Planning Commission Issues Report

Subject: Zoning Map Amendment Issues Report

Meeting Date: May 11, 2015

Petition: **P.Z. 03-2015 Sachs Properties (The Grove in Chesterfield):**

PRELIMINARY SITE PLAN

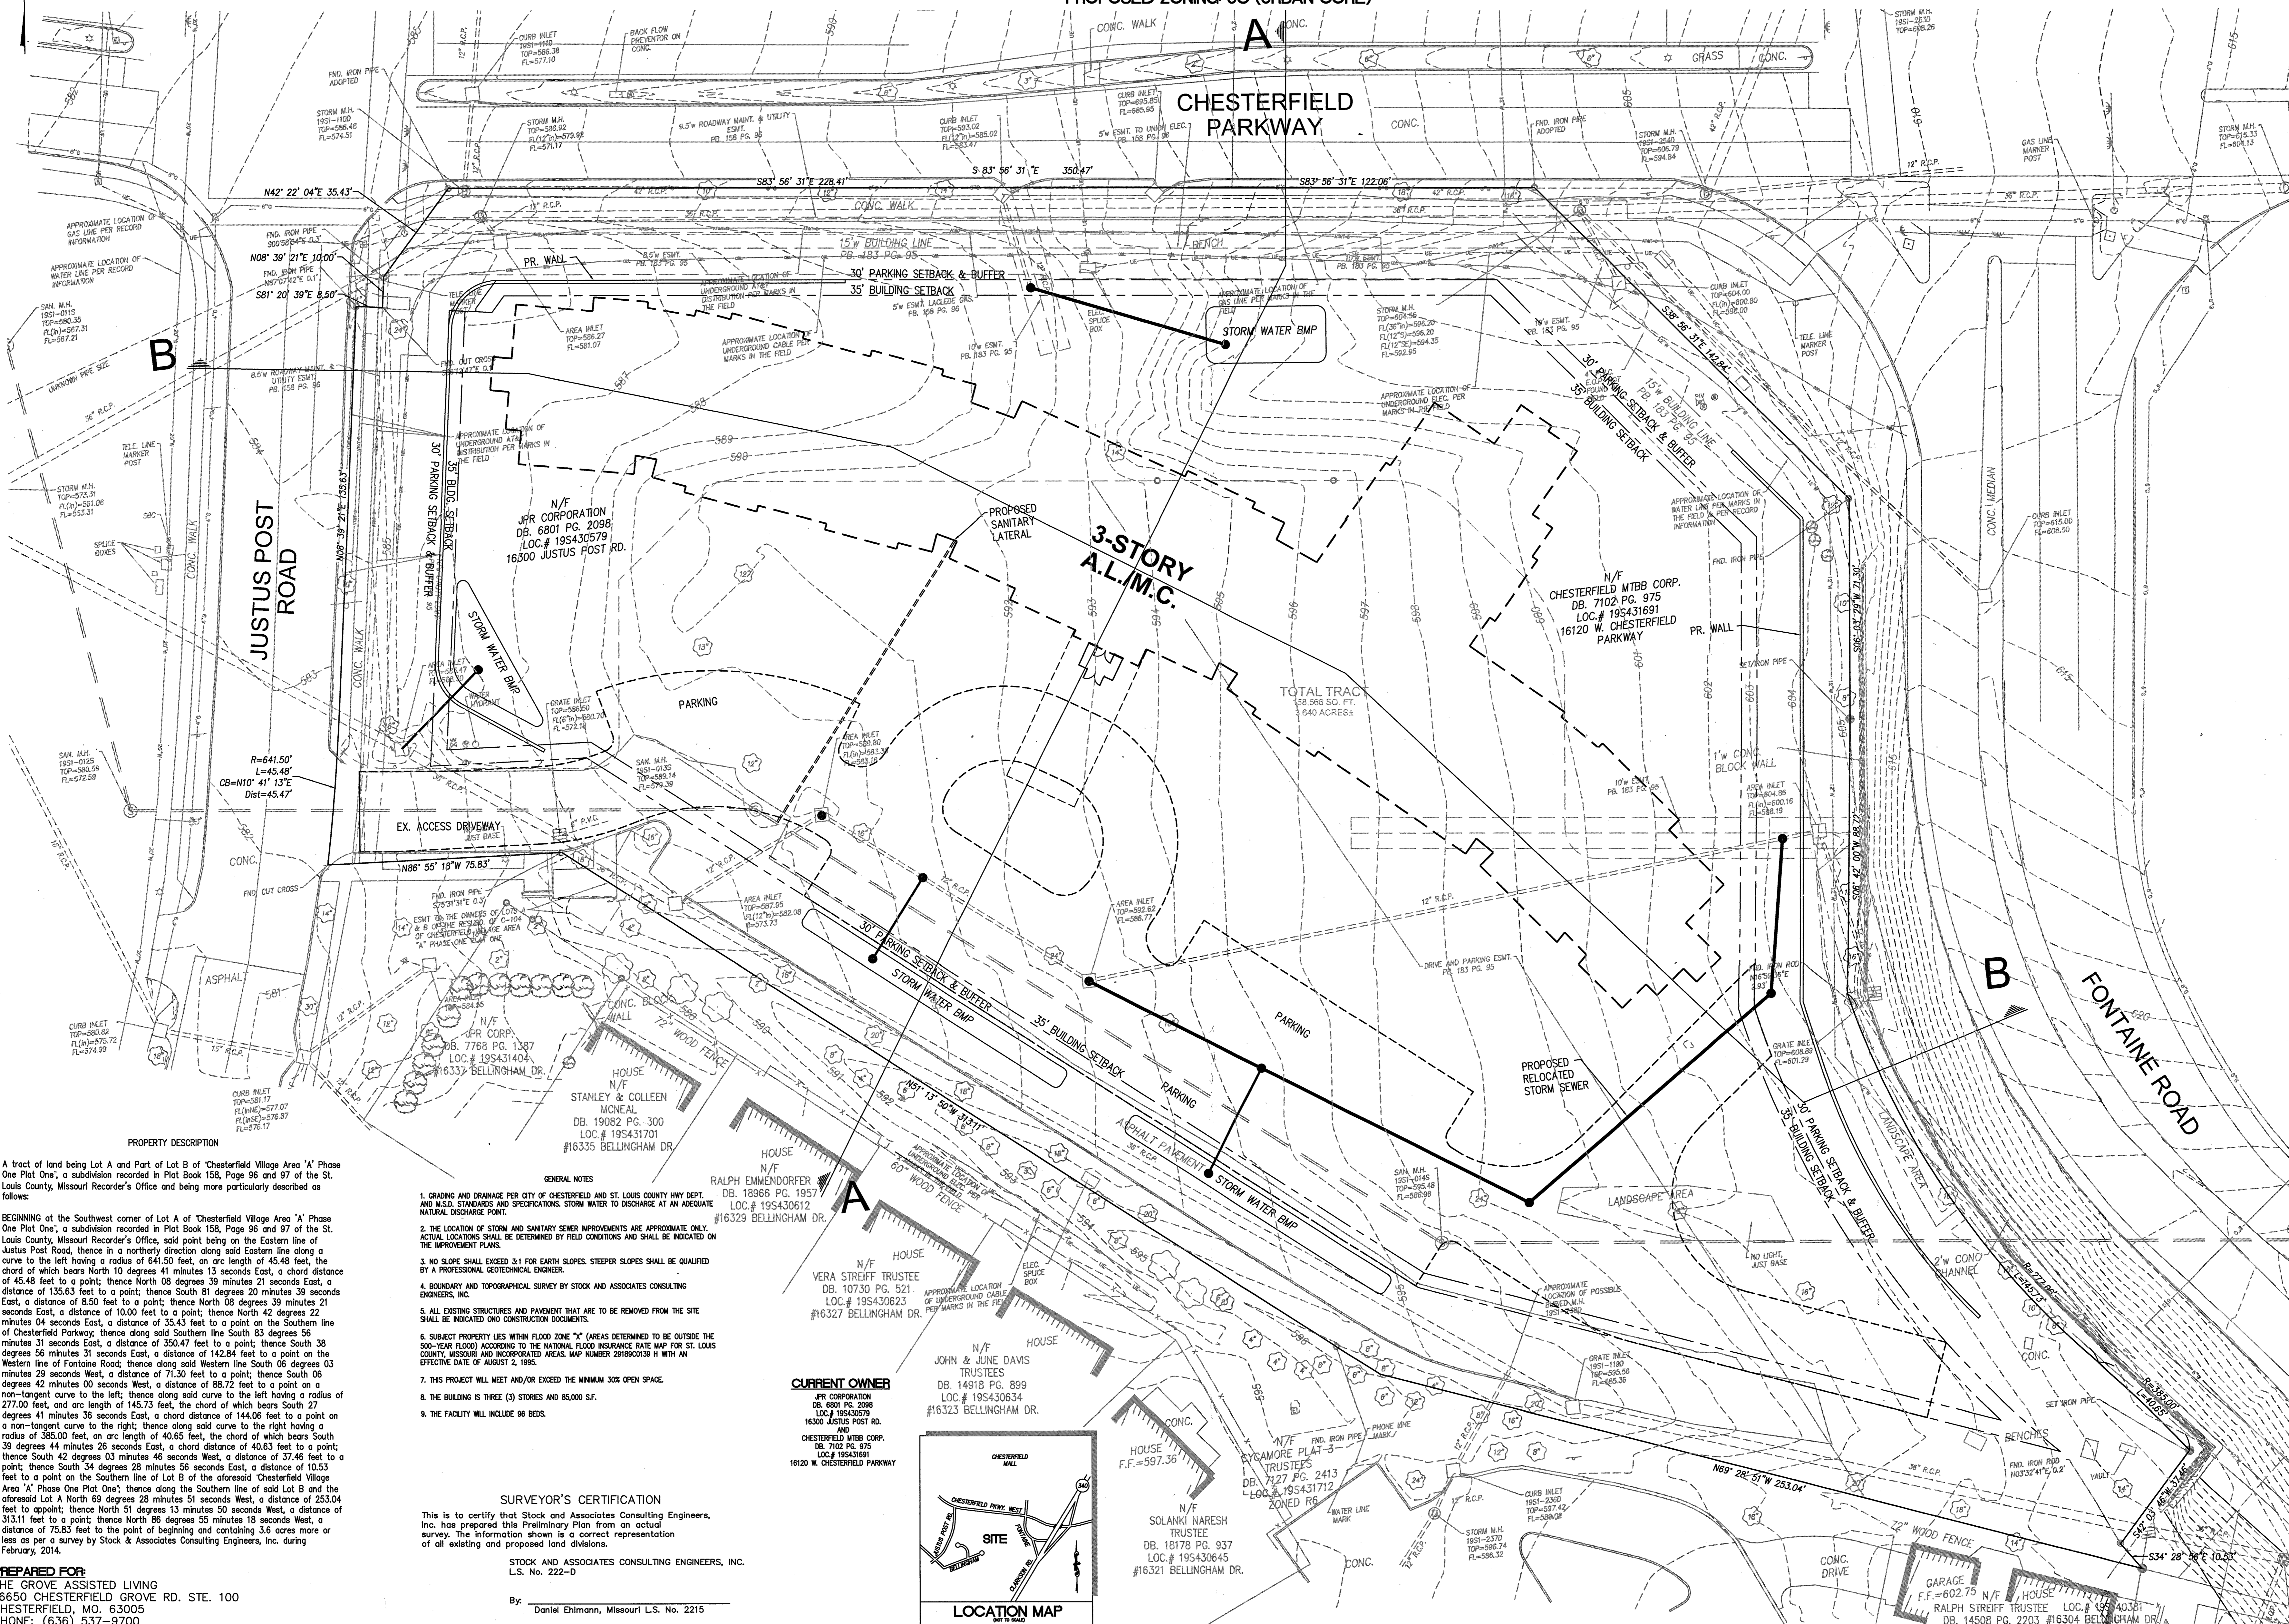
The applicant has submitted the required Preliminary Plan which depicts a proposed three-story, 85,000 square foot, 96 bed Assisted Living Care Facility and associated parking field. The building is shown on the Preliminary Plan to be pushed north from the residential areas to the south and towards Chesterfield Parkway West. Access for the site is proposed to be provided at the existing access point off Justus Post Road and not Chesterfield Parkway. Associated with the request for the UC District, minimum required setbacks and buffers are provided on the Preliminary Plan. As required, a

minimum of a 30 foot buffer is provided around the perimeter of the site. The UC District also requires a minimum of 30% open space. Per General Note #7, the project will meet and/or exceed this standard. Pedestrian Connectivity will be achieved via existing sidewalks along Chesterfield Parkway and Justus Post Road.

Based upon the issue with the height of the proposed facility and adjacent residential uses, Staff has recommended conditions within the Draft Attachment A which requires heavy vegetation and berms along this southern border to ensure ample screening of these uses. The Draft Attachment A included with this report reflects these conditions. Further conditions regarding the screening of this use may be discussed by the Planning Commission if warranted.

In addition to these above items staff will require the following amendments to the Preliminary Plan to be reviewed by staff prior to being presented to the Planning Commission;

1. Provide the approximate square footage of the proposed structure as a note on the Preliminary Plan.
2. Provide the number of beds proposed for this Assisted Living Care facility. This may be identified on the Preliminary Plan or within a narrative.

The building will be 85,000 s.f., and contain 96 beds.

SITE SECTION A-A
SCALE: 1"=20'(H)(V)

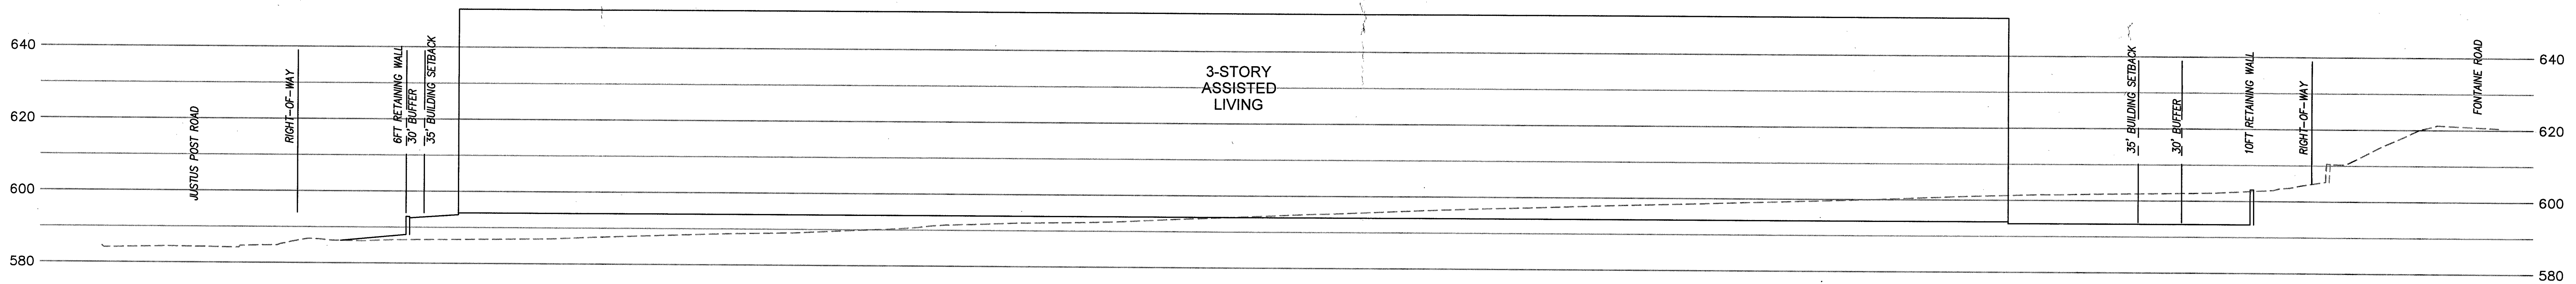
Concern was raised about the proposed height of the assisted living facility in relation to adjacent residential uses. Both Planning Commission members, as well as members of the public who spoke at the public hearing, discussed this as a concern. The proposed height of the Assisted Living Facility is three (3) stories, with homes to the south and west at one (1) and two (2) stories in height. The issue being that the relatively close proximity of the proposed Assisted Living Care Facility, as well as other proposed uses, could have negative effects on existing homeowners. Per the petitioner's Issues Response, see attached letter to this report, with the combination of extra buffering associated with a UC District of thirty (30) feet, proposed storm-water facilities along the southern property line, additional planned landscaping within the required buffer and a distance of approximately 158 feet from the proposed Assisted Living Facility and the south property line, any visual issues with the proposed height of the building should be minimal. Staff has added language into the Attachment A to require dense vegetation and a berm along the southern property line. Planning Commission may further evaluate this proposal and provide additional buffer, landscaping, etc. if deemed appropriate. The Planning Commission may also further evaluate a more restrictive setback along the south property line with additional buffering. At this time, Staff believes the minimum 35 foot structure setback is appropriate with the addition of the above conditions of additional dense landscaping along this property line.

2. Concern was raised about the proposed height of the assisted living facility in relation to adjacent residential uses. Provide information on ways to assist in mitigating the building appearance from adjacent residential uses. Discussion by the Planning Commission centered on the use of additional landscaping and/or berms to assist in screening/or these residential uses.

There are six (6) homes which are located approximately 40 feet south of the project's south property line. Within the 40 feet, and extending approximately ten (10') feet onto the subject property, is an existing Landscape Berm 2-3 feet tall, constructed sometime after 1979 when Sachs originally developed the two (2) former office buildings. Existing today in this area is dense landscaping, with a few visual gaps.

As part of this project's Site Design, the ten (10') feet of buffer on the subject property will be increased to thirty (30') feet. Within the thirty (30') feet, additional landscaping, and stormwater BMP's will be placed in lieu of the existing asphalt pavement. The building is being placed approximately 158 feet north of the south property line to increase its separation from the existing residents. The combination of existing landscaping, new landscaping, and horizontal separation addresses the height of the building relative to the homes.
